**Addendum No. 1**

**August 28, 2025**

**City Project No.: 23-069**  
**Roads Program Capital Improvement Project**

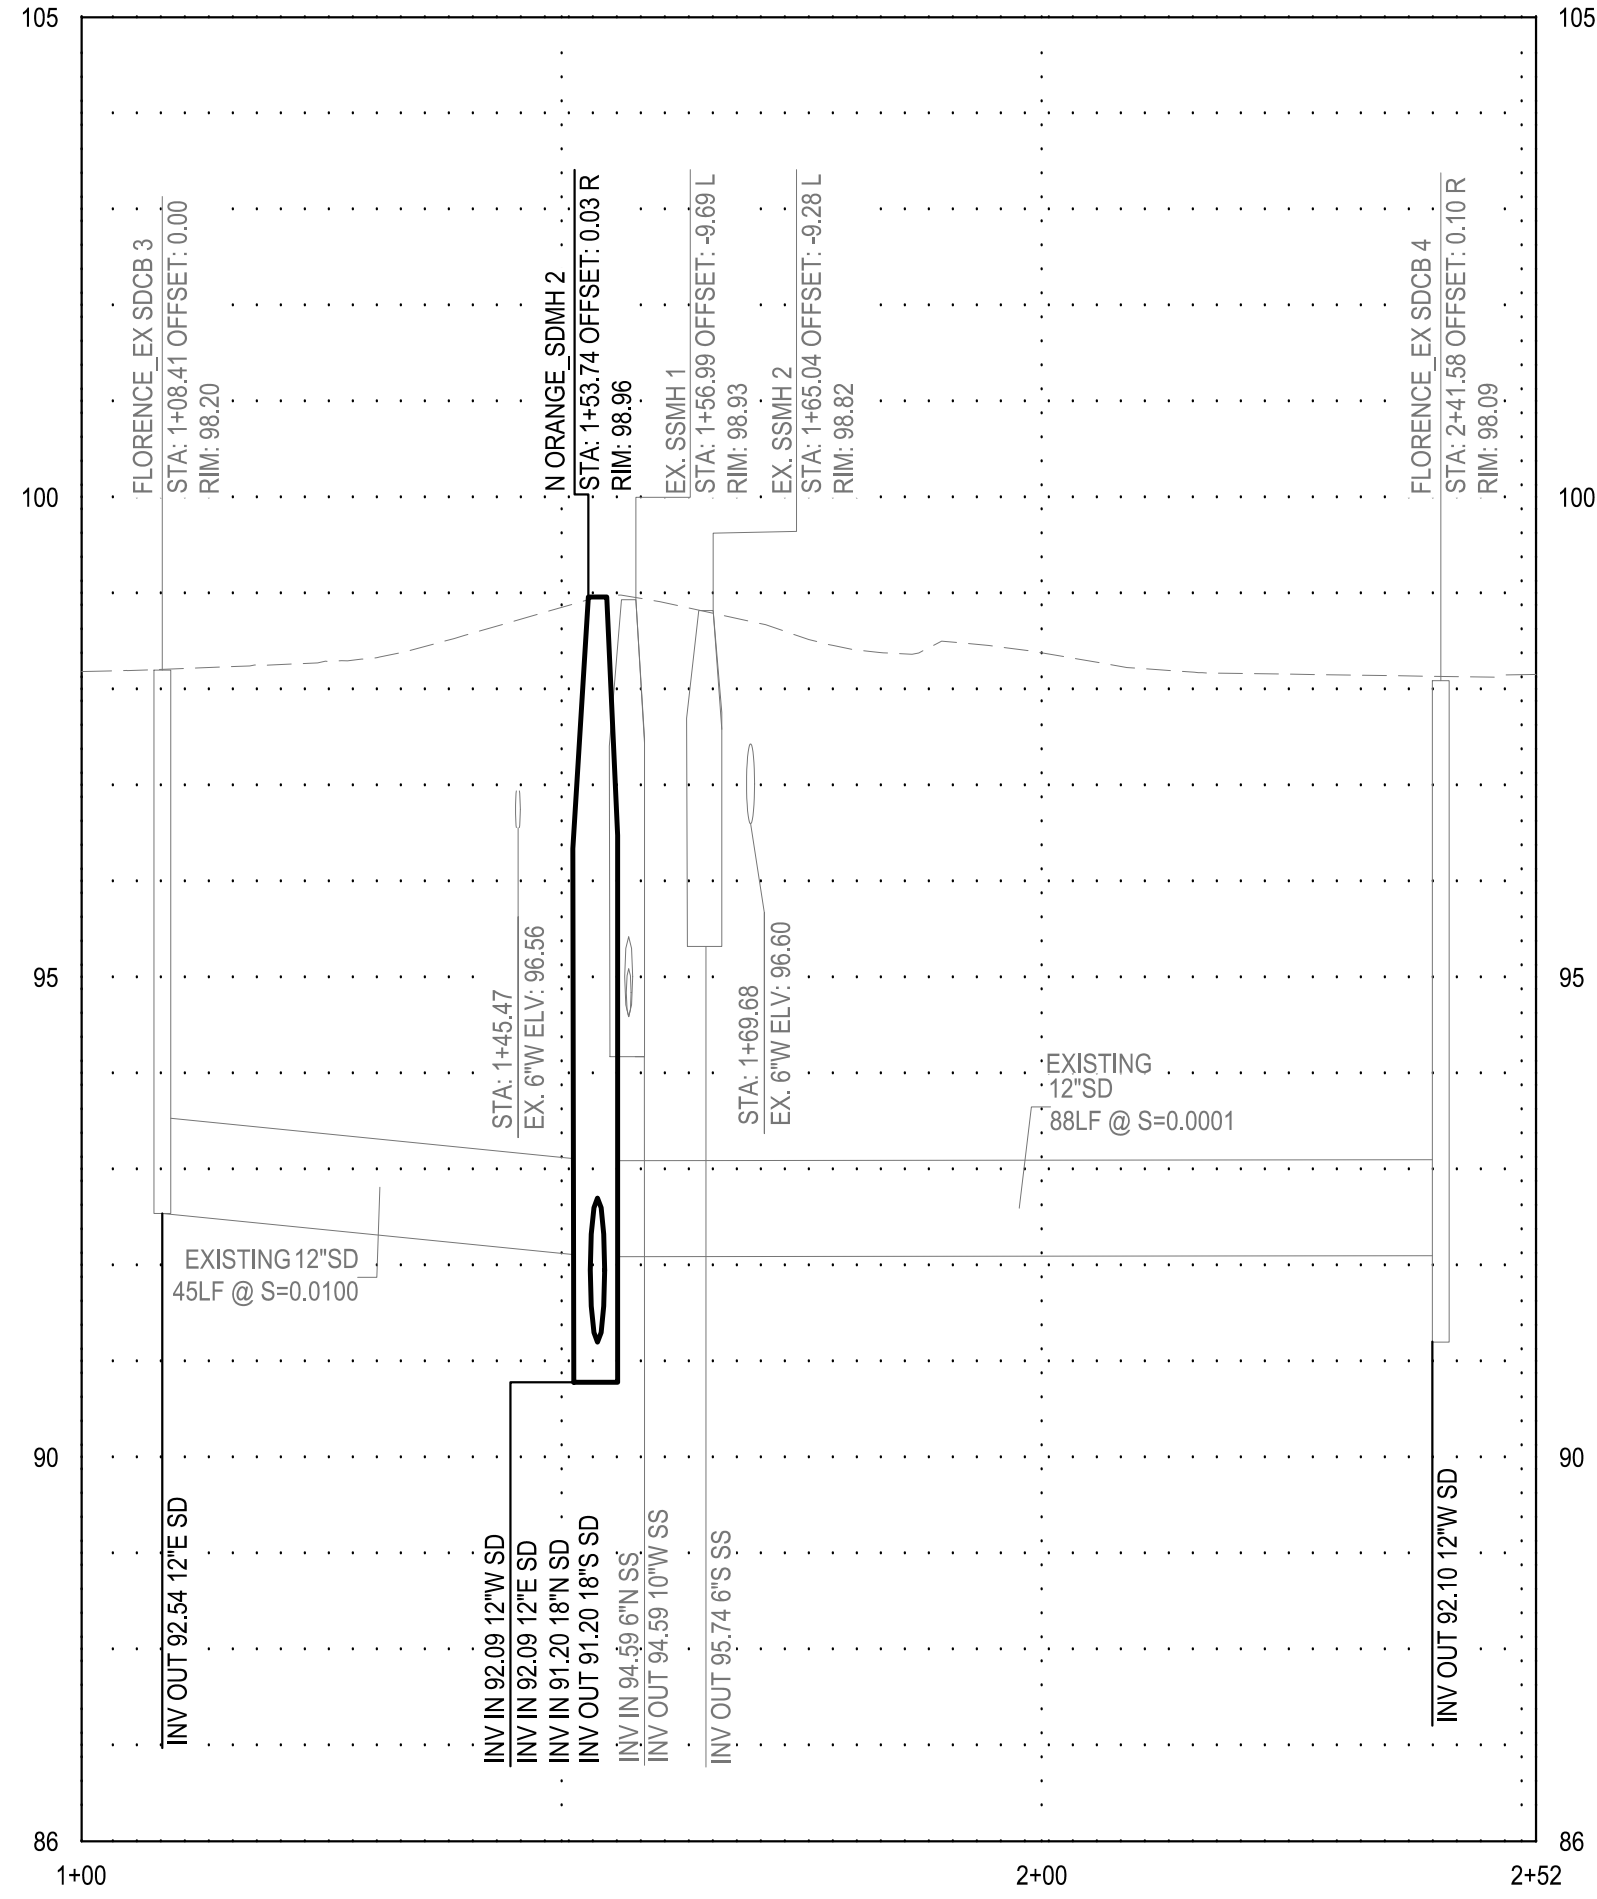
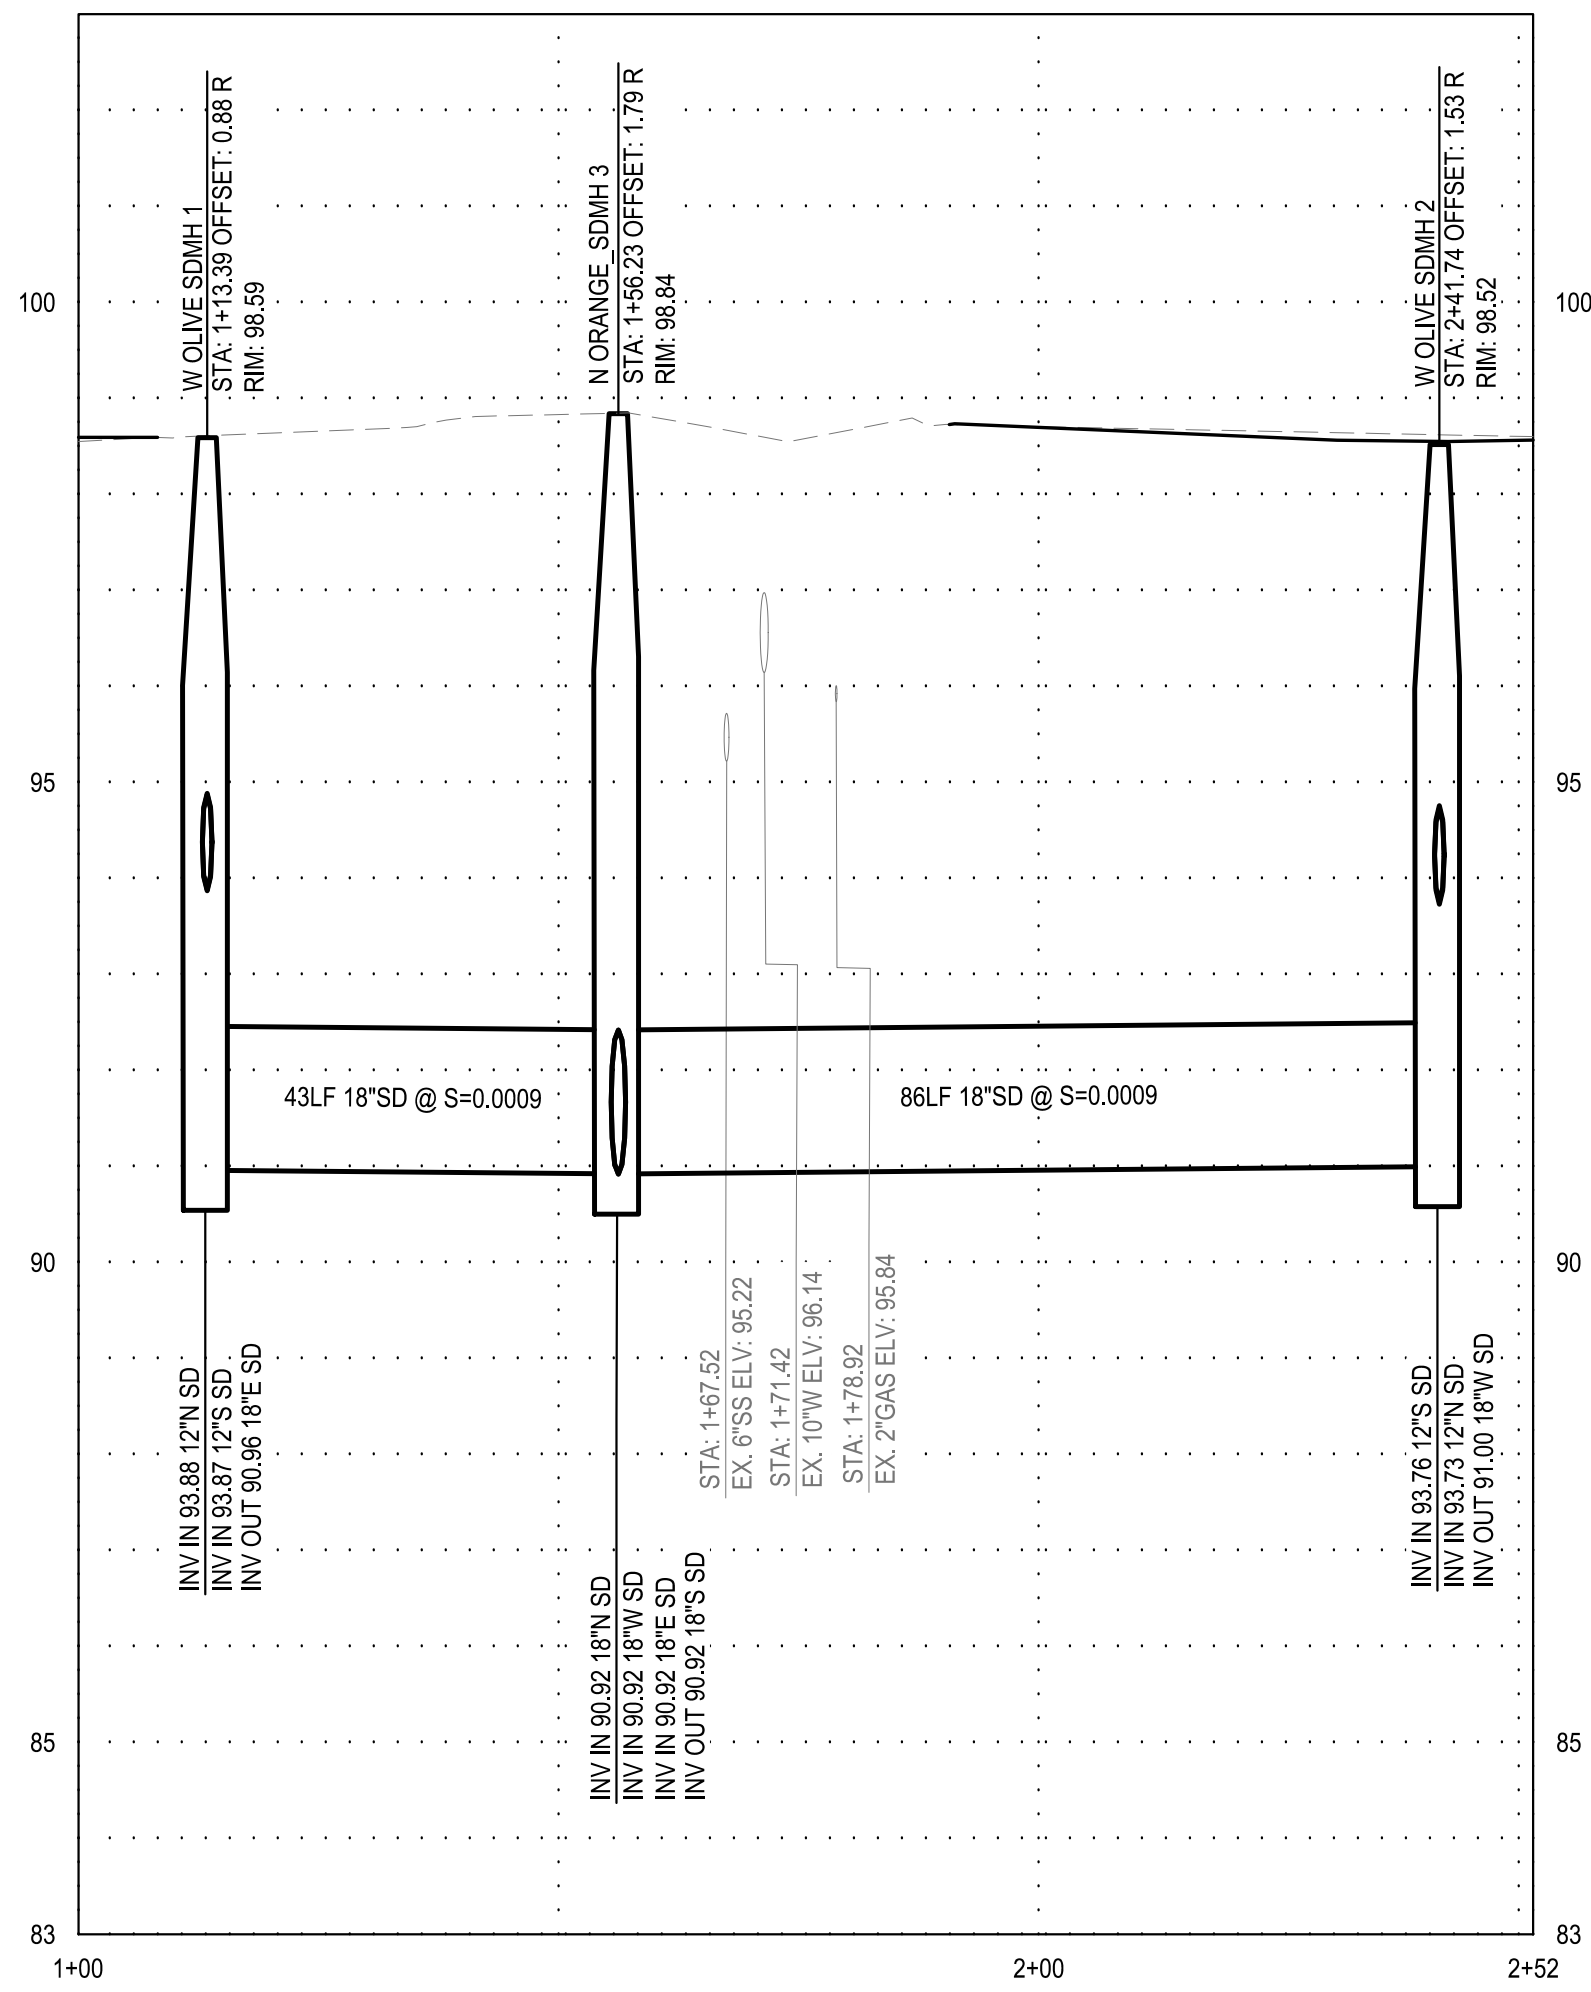
Sheet 97, The 12" storm drainpipes have been revised to be shown as existing. The text "EXISTING" has also been added to Cross Section 2 on Sheet 97.

Q15: Sheet 97 and 98, along with a few other plan sheets show a 12" SD pipe to be installed, however it is unclear where the 12" pipe is paid in your bid breakdown. How will the 12" pipe be paid?

A15: The 12" storm drainpipes shown on Sheet 97 have been revised to be shown as existing. The text "EXISTING" has also been added to Cross Section 2 on Sheet 97. The 12" storm drain pipe are the existing bubble-up storm pipe to be connected to new storm drain network.
